REPORT FOR INDEPENDENT INSPECTOR

17 Pasture Road

- 1.1 Proposal - Two storey rear extension, two storey side extension and first floor extension above part of garage plus roof extensions to existing hips to form gables and alterations to fenestration.

Current rear elevation

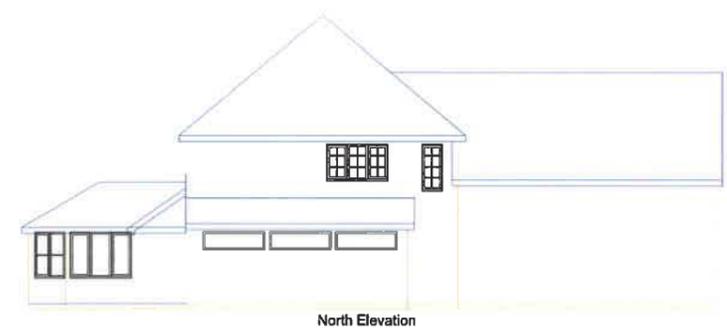
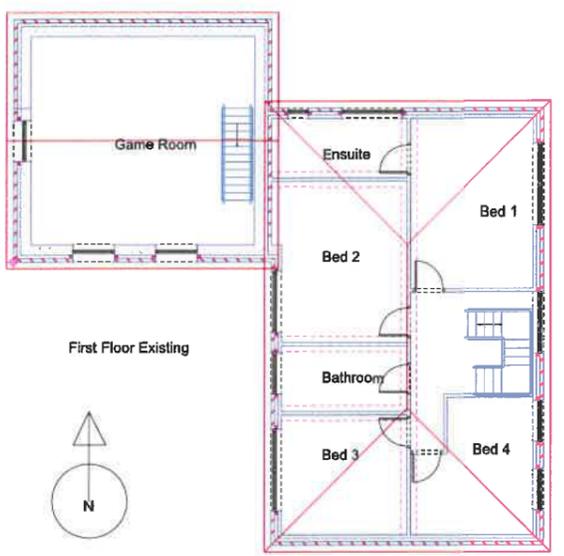
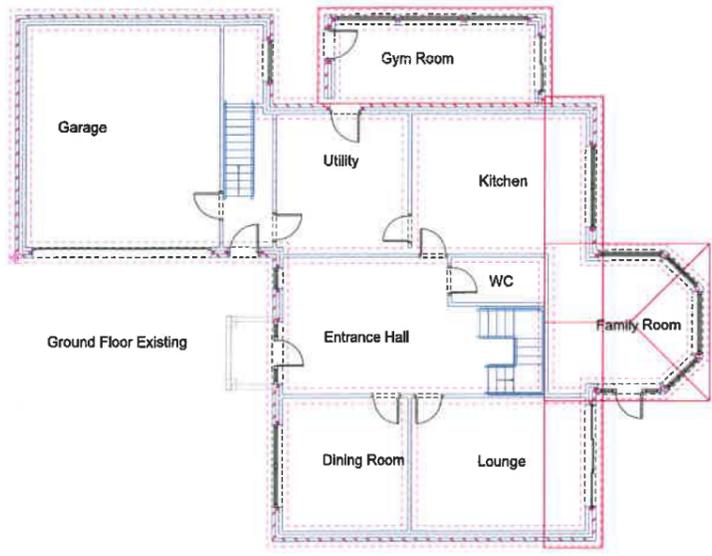
Relationship [REDACTED] which shows a narrow strip between the two buildings which will be exacerbated by the proposed side extension.

Drawing Title
 Existing Elevation

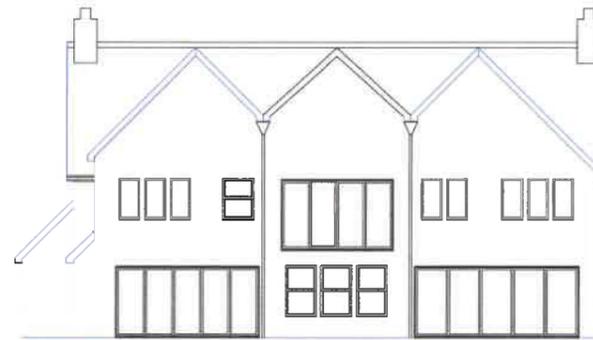
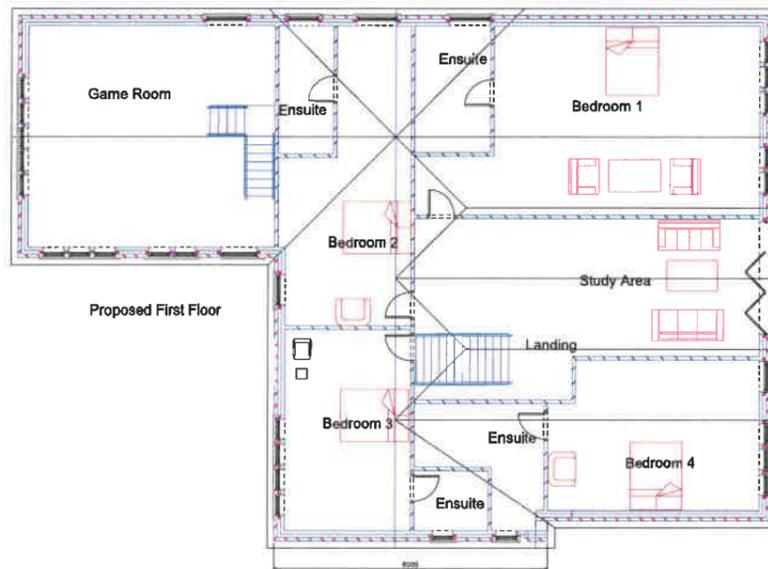
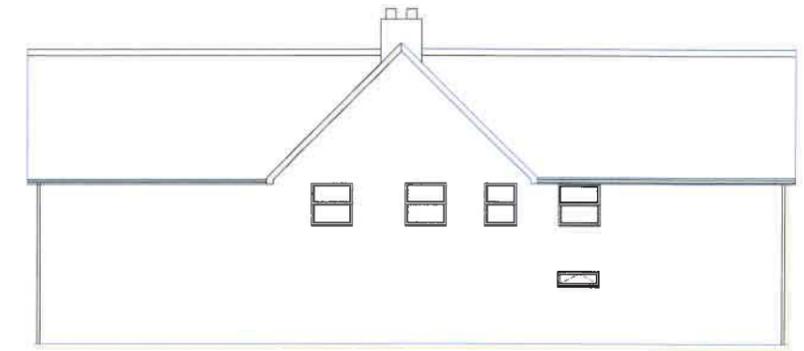
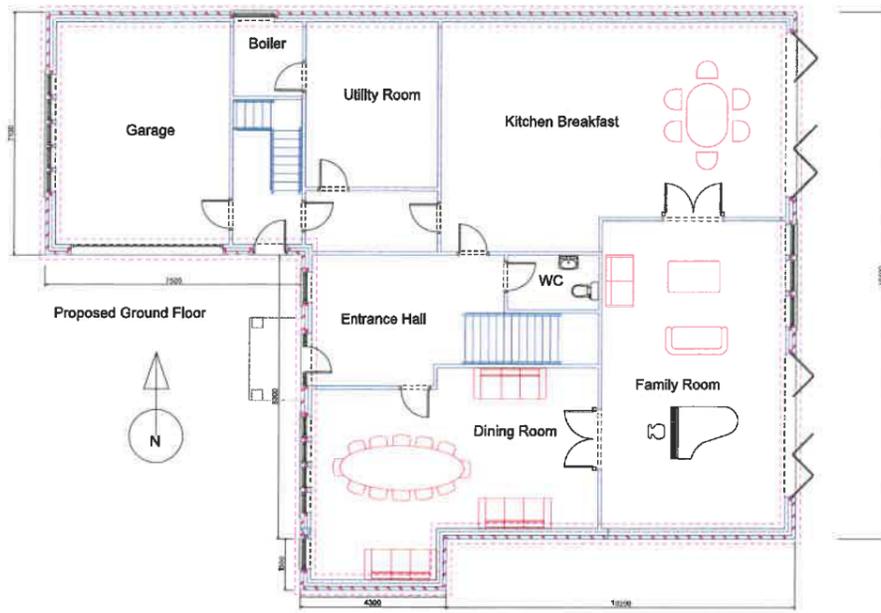
- 6.1 At the meeting of the Advisory Management Committee, concerns were expressed regarding discrepancies in the eaves and overall height which appear to be different on each elevation. The pitch of the roof slope also shows discrepancies between the existing and proposed. This suggests that the intention may be to demolish the building and erect a new dwelling on the site, but this is not clear from the submitted plans. It also confirms the concerns that the HAS team has as to what the final external appearance of the property will be and what the overall impact on the amenity of the neighbouring properties would be.

Drawing Title
Proposed Elevations & Floor Plans

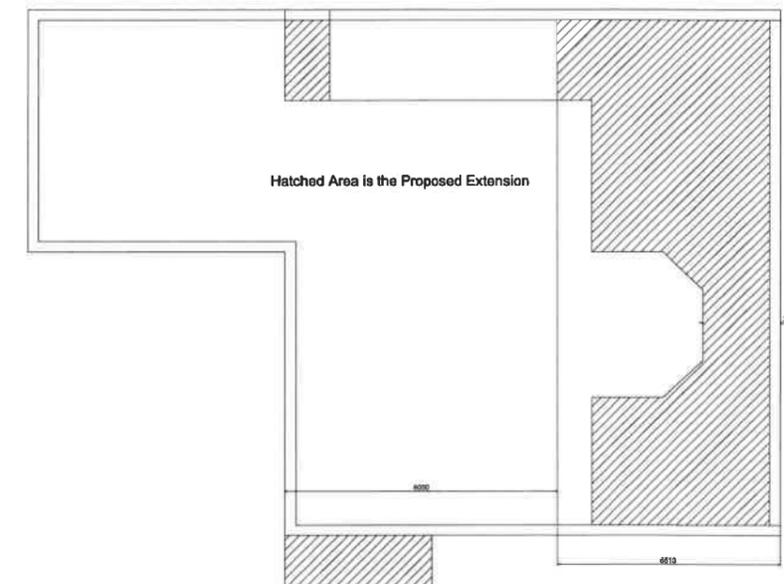
- 5.4 **Roof** – The original roof is hipped: the proposal shows a gabled roof to the main house as well as to the extension which do not reflect the original roof

design. If the original building is being retained, the roofline should remain as a hipped roof.

- 5.5 **Garage** – The garage, which already has a first floor, is to be further heightened to align with the new roof providing no relief to a large proposed side elevation the runs along the boundary [REDACTED].

The ground floor is still shown to be a garage yet has windows. What treatment are these windows going to have? Please see comments below.

- 5.6 **Windows** - The proposed windows are open glazed, which again alters the design of the property which currently has Georgian paned windows.

- 5.7 **Rear extension and elevation details** - The depth of the proposed rear extension is approximately 6.5 metres in depth although the dimension appears to have been taken from within the existing building. The closeness [REDACTED] would suggest that the depth of any rear extension be curtailed to ensure that there is space around the houses within this locality.

The proposed design bears no relationship to the existing building that is to be extended and the design is very poor and contrived. The gables are not equal nor balanced, which results in a rather odd, slim, single storey element which further unbalances the elevation. The fenestration is poor and contributes to the poor quality of the proposal. Again, is this all in brick? Is the tile hanging remaining and will the windows and doors have stone surrounds?
